# ARCHAEOLOGICAL REVIEW COMMITTEE HEARING THURSDAY, October 3, 2019, at 4:30 PM CITY HALL LAND USE CONFERENCE ROOM CITY HALL - 200 LINCOLN AVENUE, SANTA FE, NM \*\*\*AMENDED\*\*\*

## MINUTES OF THE CITY OF SANTA FE ARCHAEOLOGICAL REVIEW COMMITTEE HEARING City Hall Land Use Conference Room October 3, 2019

Figure 5: Site Map of LA76232 Showing Features 1-4 (Winters, Brown 2019)

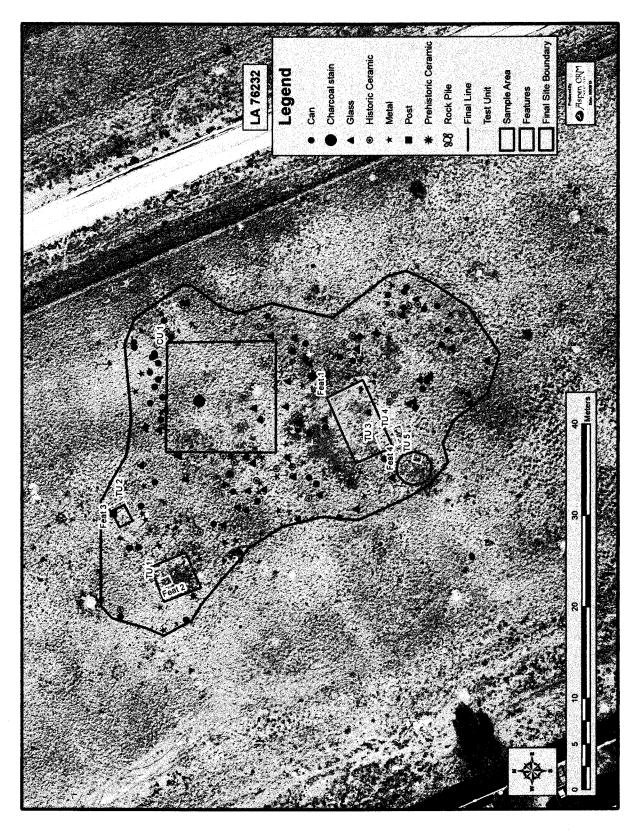
Mr. Zinn asked Mr. Winters to comment about the corral on report page 13, Figure 5.

Figure 12: Site Map of LA76232 Showing Features 1-4, Test Units 1-5, Collection Unit and Artifact Scatter (Winters 2019, Aspen CRM Solutions)

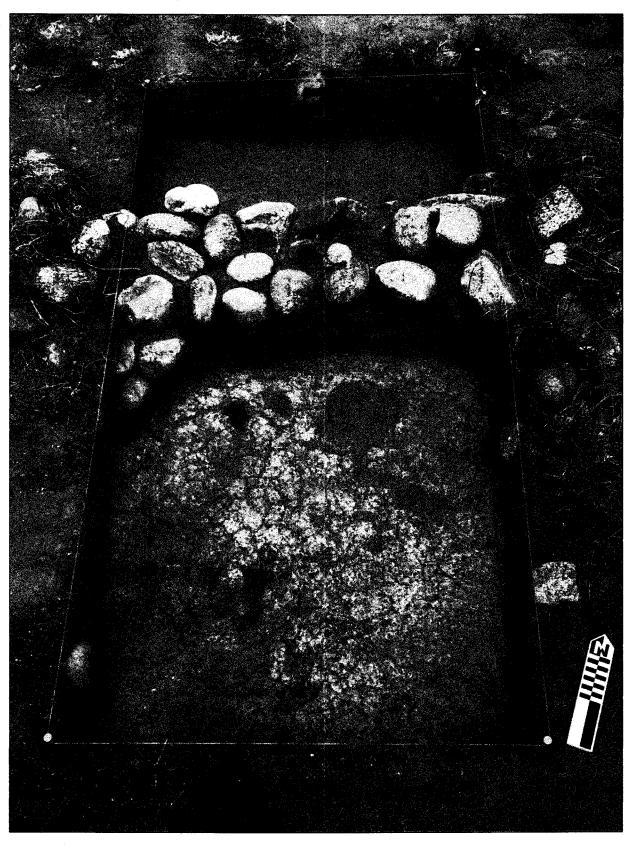
- Mr. Pierce continued, "The only other question I had, this would be on your page 41, packet page 42. So, the way that I read Figure 13, you have this Feature 5, the corral, outside of the site boundary. That can't actually be. You can have two site boundaries, but Feature 5 still needs to be within a site boundary. Right. So it's still within the site boundary. All you have is a future boundary. It's a two-part site, that's... it's got part of it over here, part of it over here, but..."

- Mr. Pierce said no. What he is saying is that he thinks there is a feature boundary around Feature 5, but not a site boundary around it.
  - Mr. Winters said then change the feature boundary into a site boundary.

- Mr. Pierce said that is correct because you cannot have a feature outside of the site, if it's a feature, it is a site. So you would have to call this one site with two parts or two sites.

- Mr. Winters said, "I guess my reservation and you understand this, is when you make the dimension change, and it's a whole different thing, in terms of the square anchorage and footage and stuff. But I certainly, yes, can bring that down and encompass the...."
